2nd Further Information

**Temporary Open Storage of Construction Materials and Machinery with Ancillary Facilities
and Associated Filling of Land for a Period of 3 Years in "Agriculture" Zone,
Lots 1161 S.B RP (Part) and 1162 (Part) in D.D. 82, Ta Kwu Ling, New Territories**

(S.16 Planning Application No. A/NE-TKL/840)

DWG. TITLE	
FSIs PROPOSAL	
DWG NO.	VER.
APPENDIX II	001

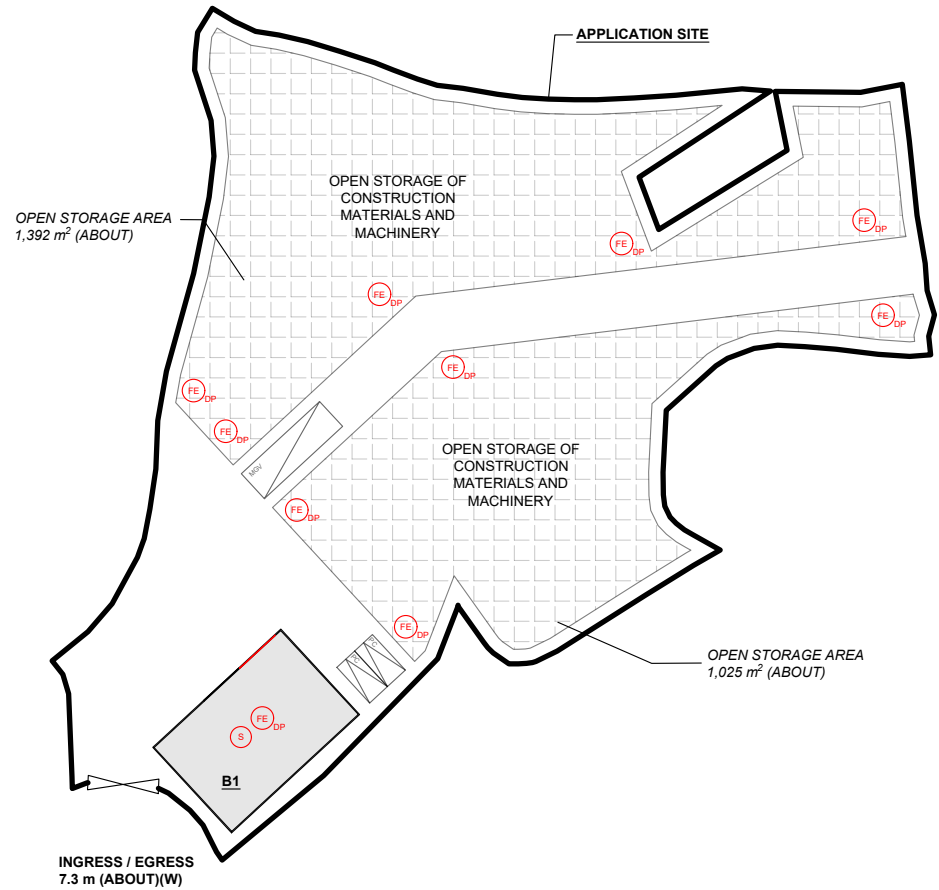
Comments of the Director of Fire Services (D of FS)		
(1)	For area designated for open storage, suitable type of portable fire extinguisher(s) shall be provided in accordance with the formula = storage area(m ²) x 0.003 [e.g. 1392m ² x 0.003 = 4.176 ≈ 5 (round up)]; and	Noted. The revised FSIs proposal is enclosed at Appendix II .
(2)	The provision of portable fire extinguisher(s) shall be placed at prominent locations that are easily accessible by users within the application site.
